DOCKET NUMBER  
 PROD. & UTIL. FAC. 50-317,318

November 6, 1979

Your assistance in evaluating the enclosed materials relating to the radiological impact of the operation of the Calvert Cliffs Nuclear Power Plant is earnestly solicited.

# POWER PLANT CUMULATIVE ENVIRONMENTAL IMPACT REPORT

Figure IV-1. Locations of radionuclide discharges into Chesapeake Bay

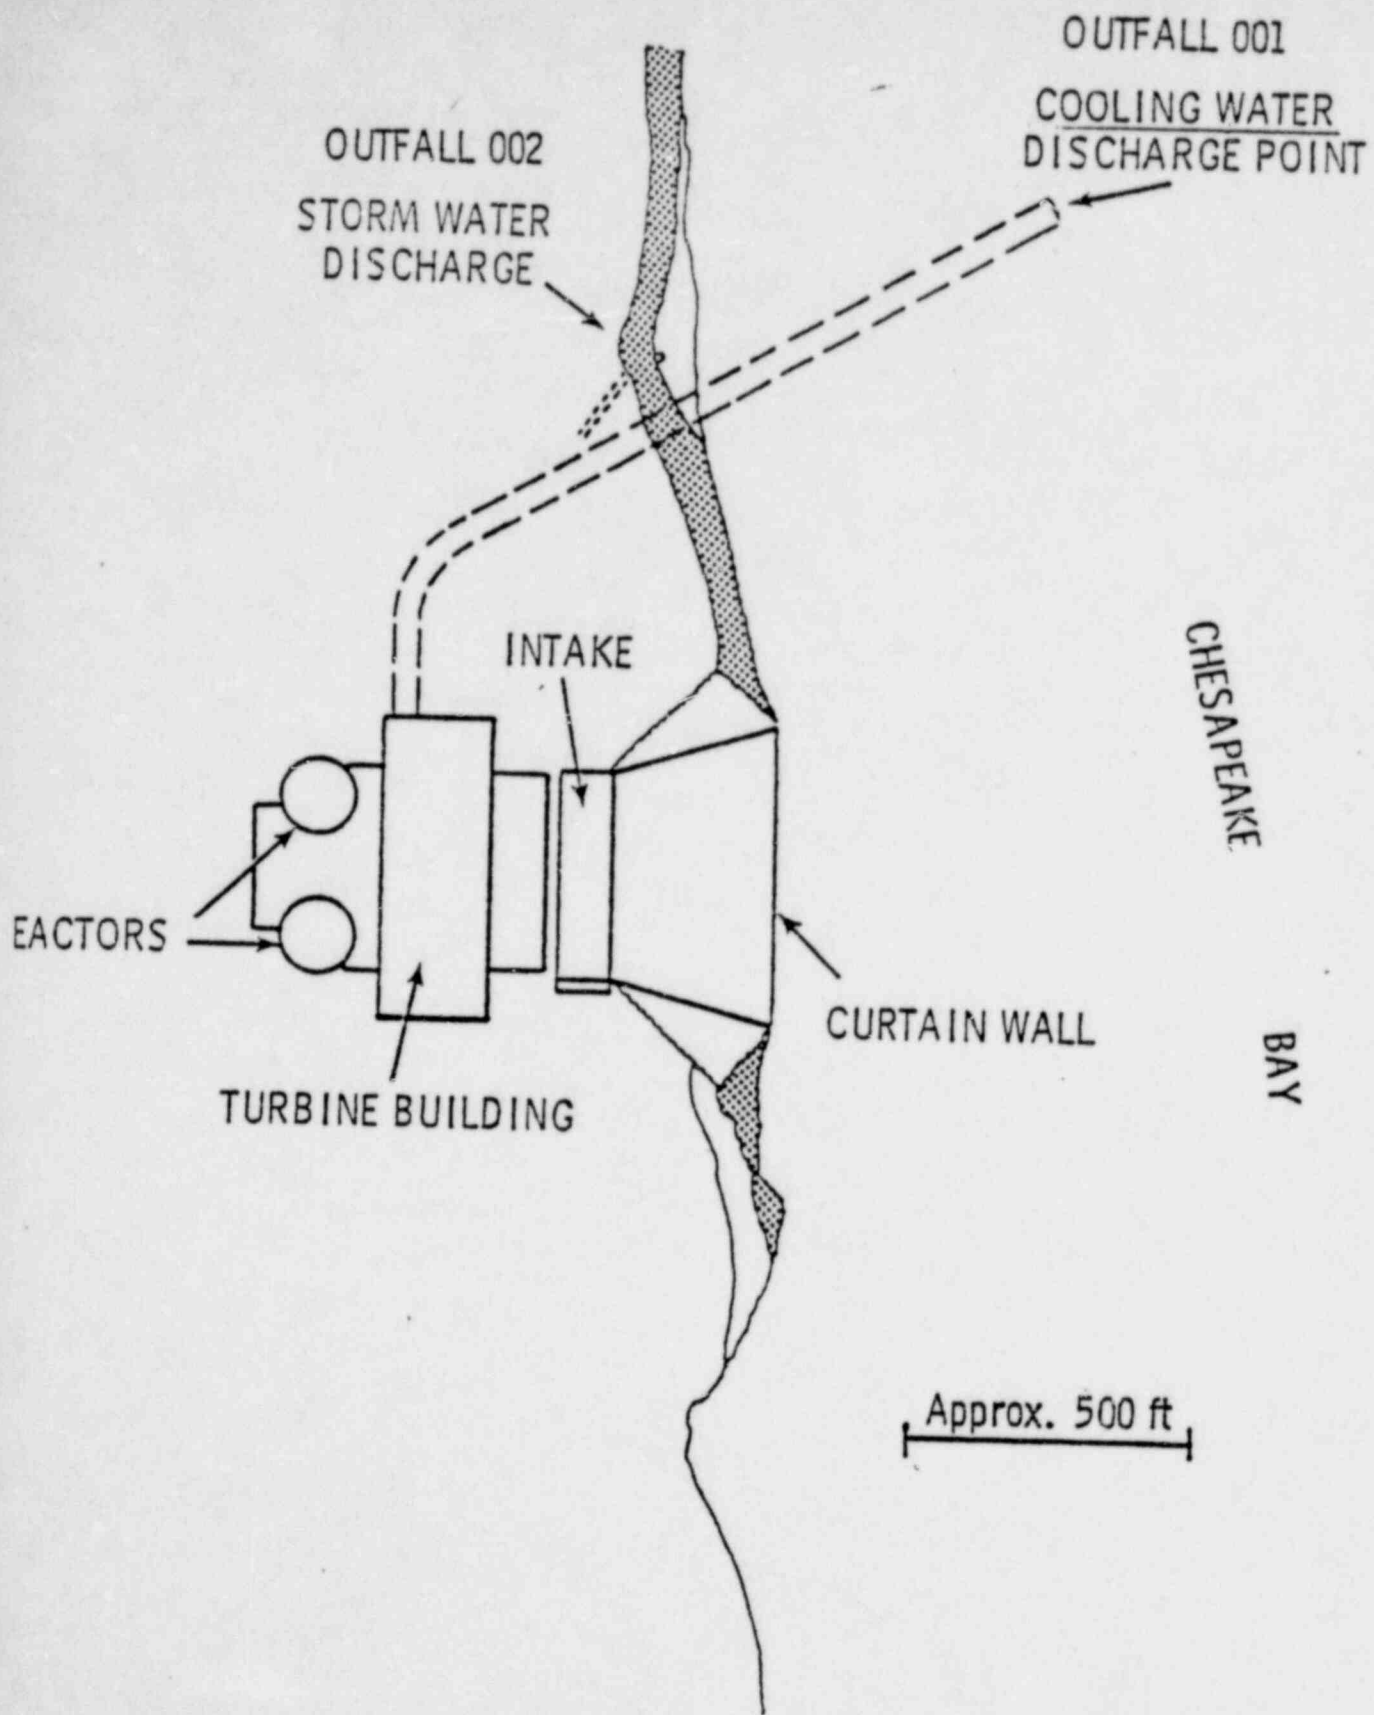
5. Storm water runoff samples at the Calvert Cliffs plant have contained these radioactive isotopes: Co-60, Co-58, Mn-54, Cx-134, and Cs-137. Is this cause for concern?

Figure IV-2. (A) Gamma spectrum of oysters from Calvert Cliffs Nuclear Power Plant discharge area showing effluent radionuclide bioaccumulation

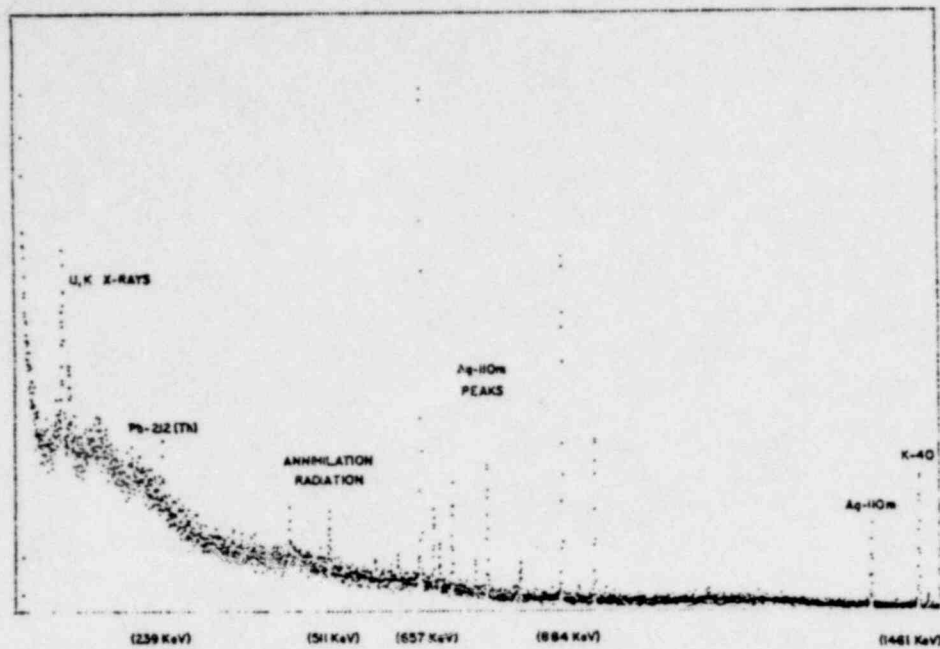
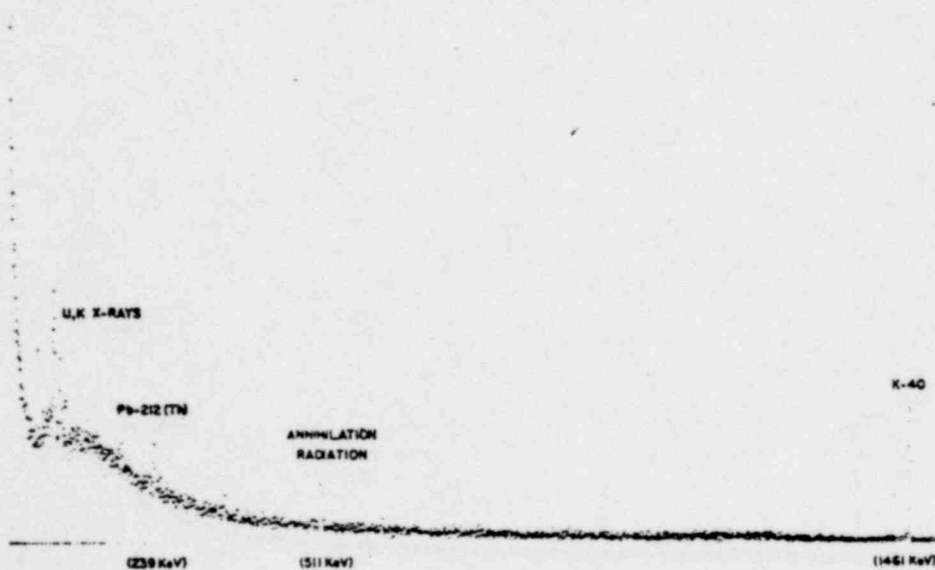
6. Ag-110m has been found in oysters six miles from the plant. This isotope was not one of the predicted liquid effluents. Is this concentration of Ag-110m in sediments and oysters near and as far as six miles from the plant cause for concern?

7. Can you comment on the analysis on page IV-19 and the chart at Page IV-21 that Ag-110m, Co-58 and Co-60 doses found in oysters near the plant produce risk levels when eaten by humans that "are minuscule compared to the normal risk levels. . .of the U.S. population today"?
